## Rev2022/0004 Traffic Referral

Despite this being the 6<sup>th</sup> set of documents to be notified for this development, the traffic report is still inaccurate, and the traffic and parking situation is still dangerous.

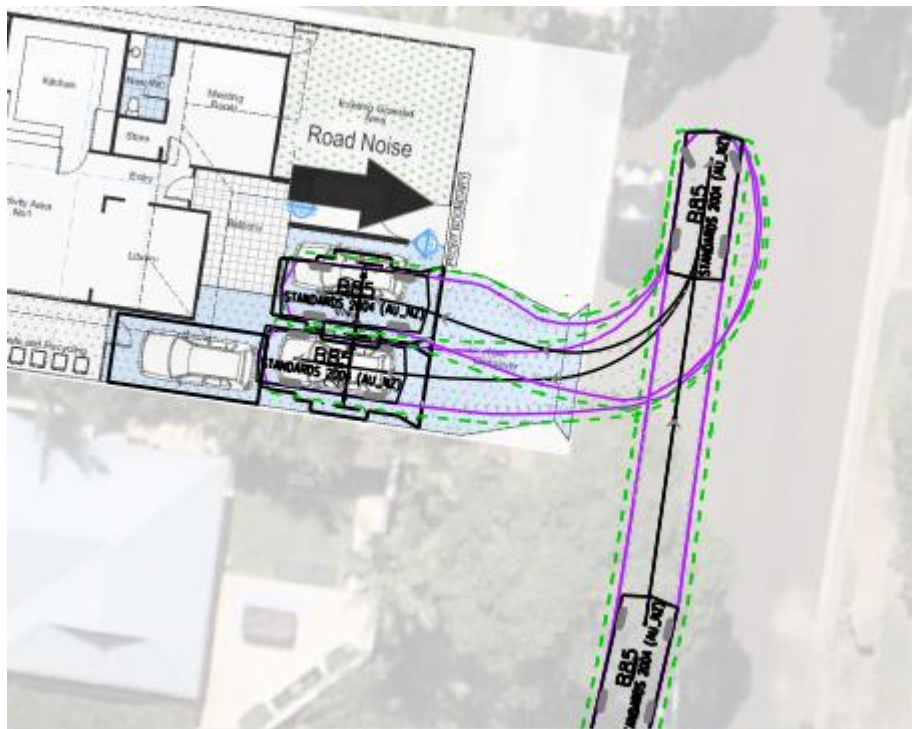
No practical opportunity to indicate left after Worrobil street exit and before the centre driveway

**Swing out right whilst indicating left in very close proximity to pedestrian crossing points, bus stop and roundabout.**

The location of the proposed child care centre in proximity to the roundabout is not conducive to these laws given that travelling NORTH along Bangaroo Street, it would be unlawful to indicate left prior to exiting the roundabout (given this would indicate turning into Worrobil Street).

The exit of the roundabout is only 15 meters from the development's driveway affording very little opportunity for drivers to indicate unambiguously.

Compounding this, the turning path shows that a left turn from a northerly direction of travel along Bangaroo Street requires a vehicle to move immediately right, and cross the centre of Bangaroo Street to make the turn.

**The location of the driveway and the required turning path is incongruous with traffic laws that require drivers to give the change of direction signal for long enough to give sufficient warning to other drivers and pedestrians, and to move close to the left side of the road when making a left turn.**

#### Complexity of manoeuvres

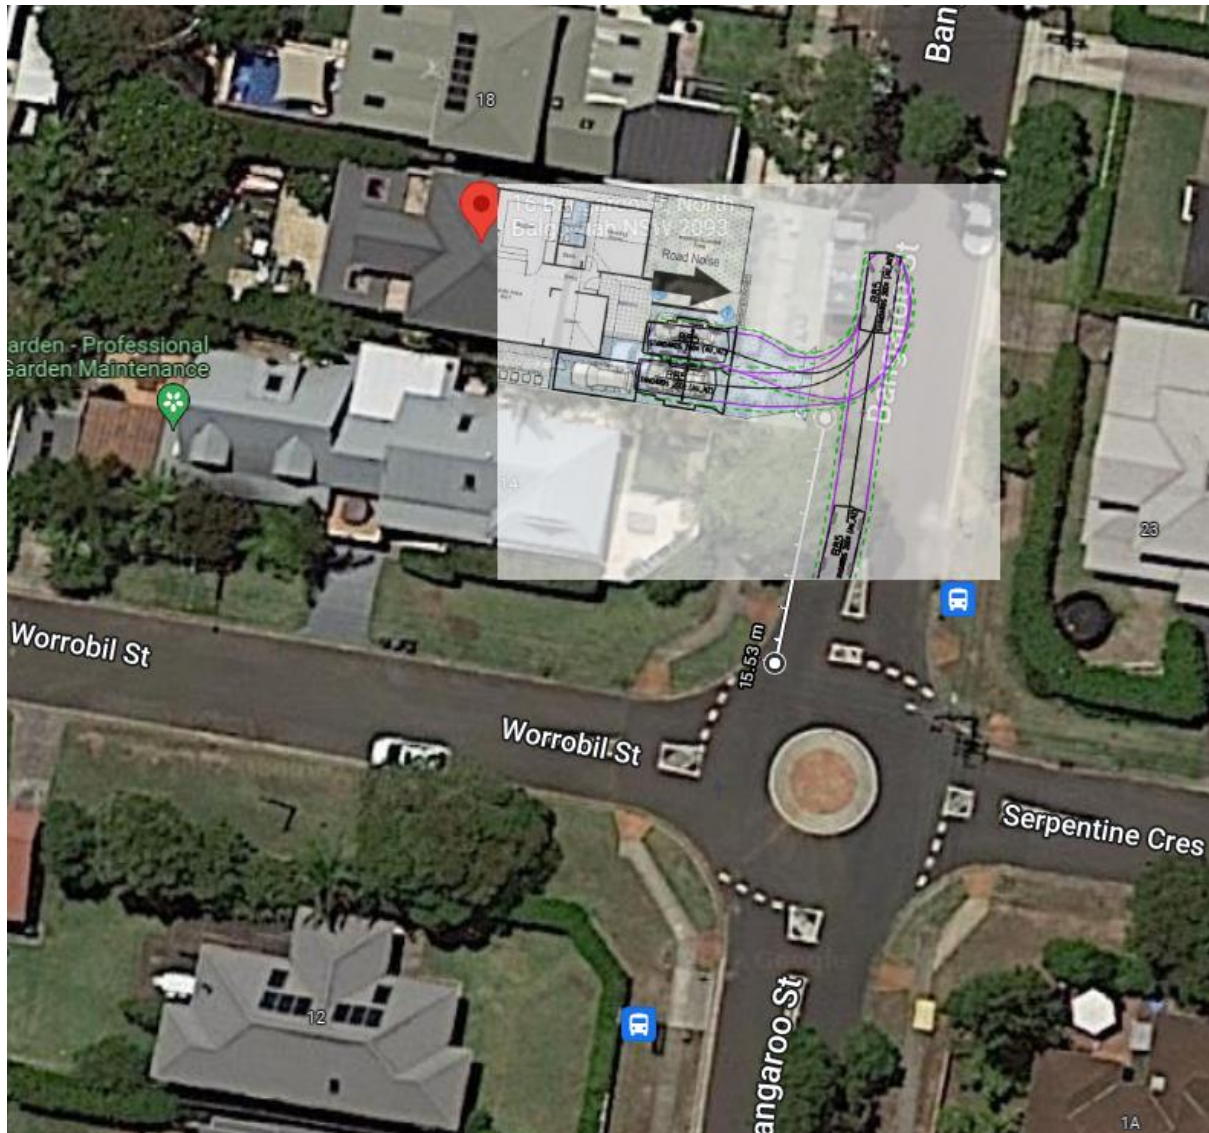
Let's be realistic, this is an incredibly complicated reversing manoeuvre to accomplish in a busy street close to an 4 way-intersection into confined spaces with barely enough room to open doors and avoid parked cars and walls.

Trying to execute this parallel park, reverse, swinging across the street, with oncoming traffic in both directions to get into a tight space between a wall and another parked car will not be executed perfectly every time, resulting in lots of back and forth over the footpath to adjust into the space – or more likely, just parking on the road in contravention to the purpose of having off street parking.

In this situation, a vehicle will have just exited the roundabout, before indicating left, then immediately moving right, and coming to a dead stop mid carriageway parallel to a parked car, then reversing against the flow of traffic and crossing into the opposing lane of Bangaroo Street whilst travelling backwards.

How would any following vehicle have any idea what the intentions of the parking vehicle are?

Unclear intentions will be highly dangerous in this location at a busy time.

It will cause accidents.

Sight lines

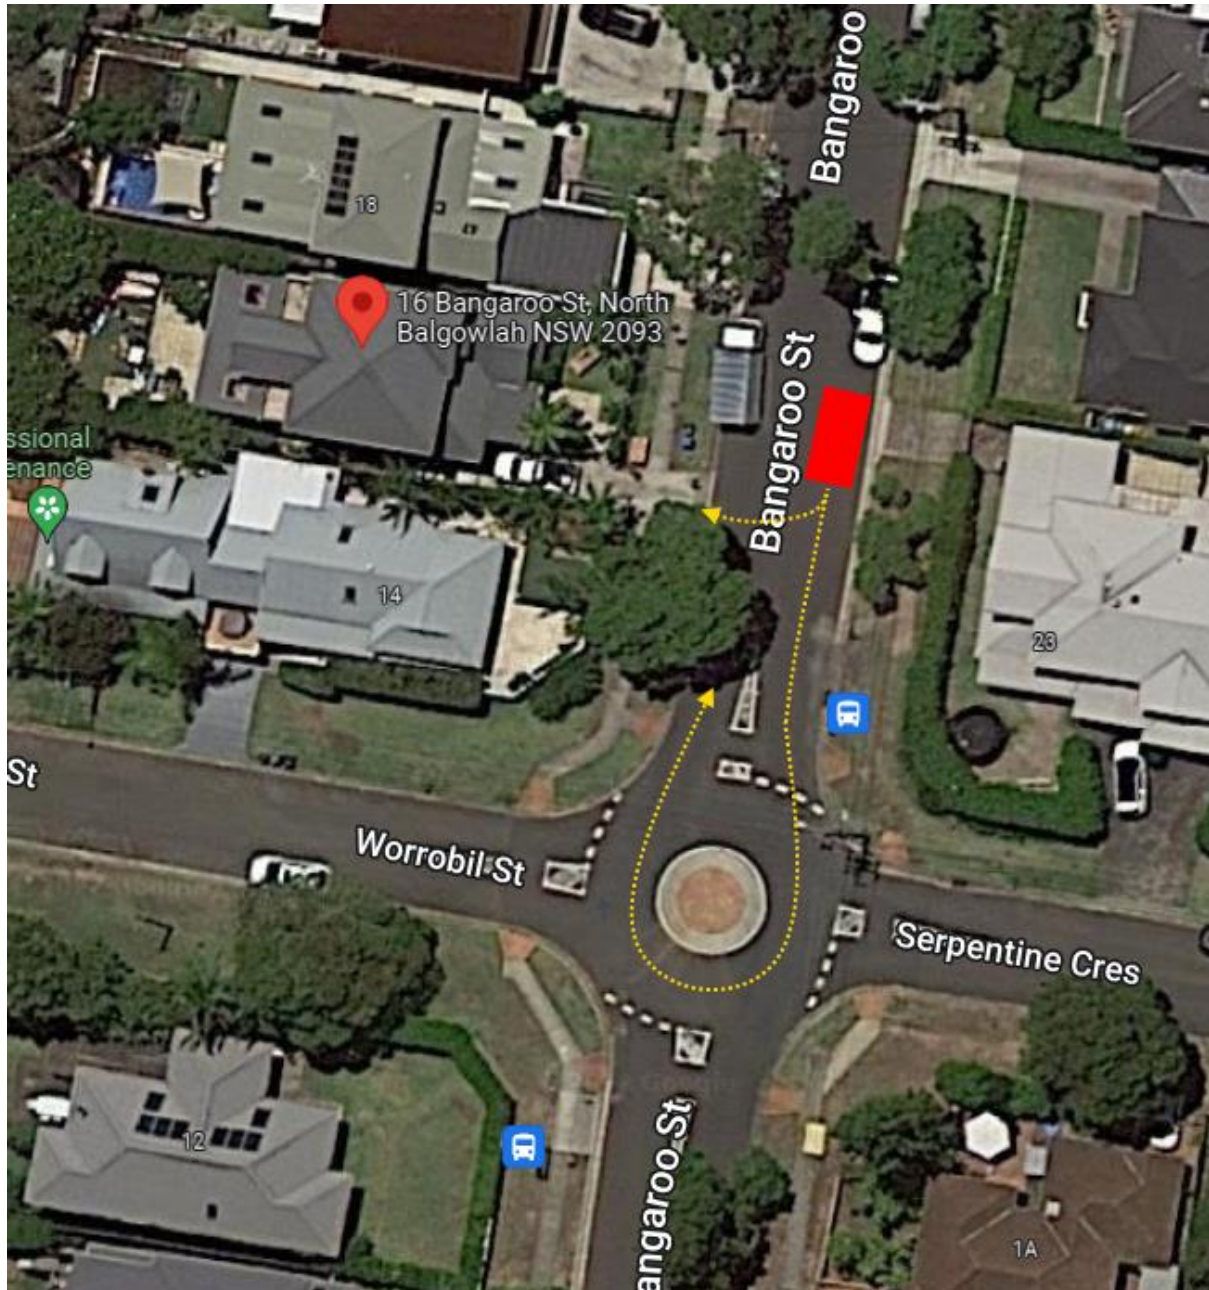
Please visit the site and approach from Bangaroo Street travelling North.

Take note of the point at which you can see if there is a vacant parking spot to park in.

You will find that you cannot see the parking spots until perpendicular to the driveway.

**Poor visibility of the parking area from approaches will lead to changes of mind close to this intersection. Indecision is highly dangerous in this location at a busy time. It will cause accidents.**

Traffic report conclusion is blatantly wrong

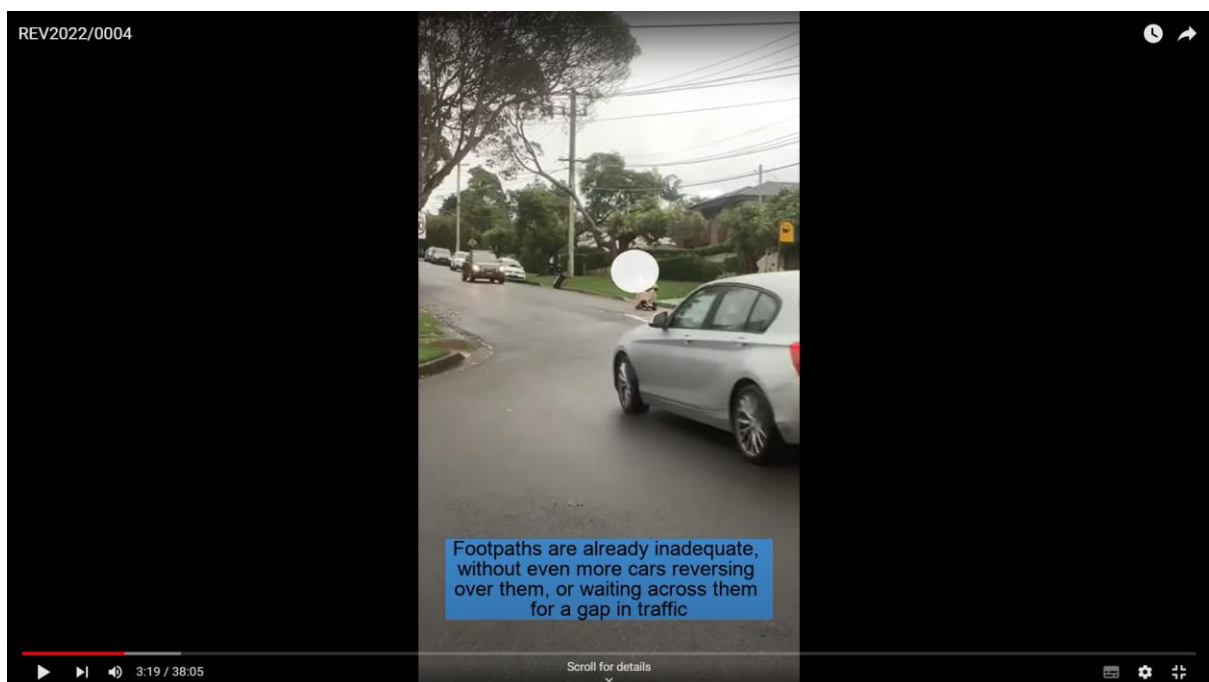
To say that a 15 minute walk is in close proximity to high frequency bus stops is clearly wrong. **No parent would consider a 30 minute round trip from bus stop to childcare to bus stop as convenient.**

The report is so out of date that it has not kept up with transport changes and there is actually a bus service (168x) 10 metres away. However, given the opening and closing times it is impractical to use this service because the afternoon service does not drop off prior to 4pm and the morning service has only 1 pick up after the 8:30am opening time, at 08:42am.

✗ In accordance with AS2890.1

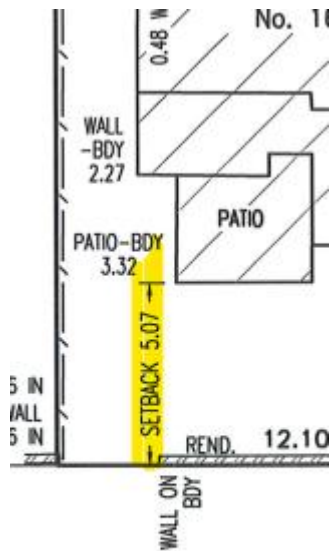
The stacked space is not in accordance with this standard.

The survey shows the compliant spaces would need to overlap each other, the patio or footpath to achieve 5.4m length.

Doors will not be able to be fully opened with 2 cars parked adjacent to each other.

This does not seem to comply in at least 3 highlighted areas.
